# Economic and Social Council

## **Proposal for Corrigendum 1 to UN Global Technical Regulation No. 13 (Hydrogen and Fuel Cell Vehicles)**

### **Submitted by the Working Party on Passive Safety\***

"Figure 3  
Drop Orientations

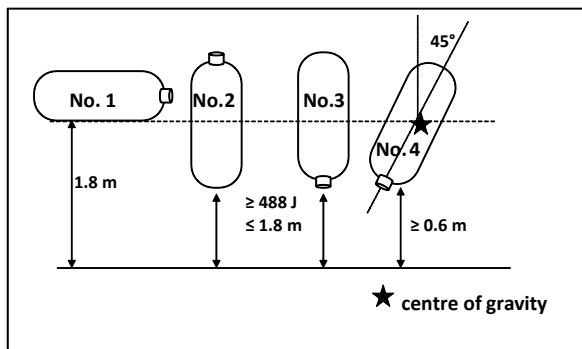
Figure 3 in paragraph 6.2.3.2., amend to read (correct the place of words in the drawing):
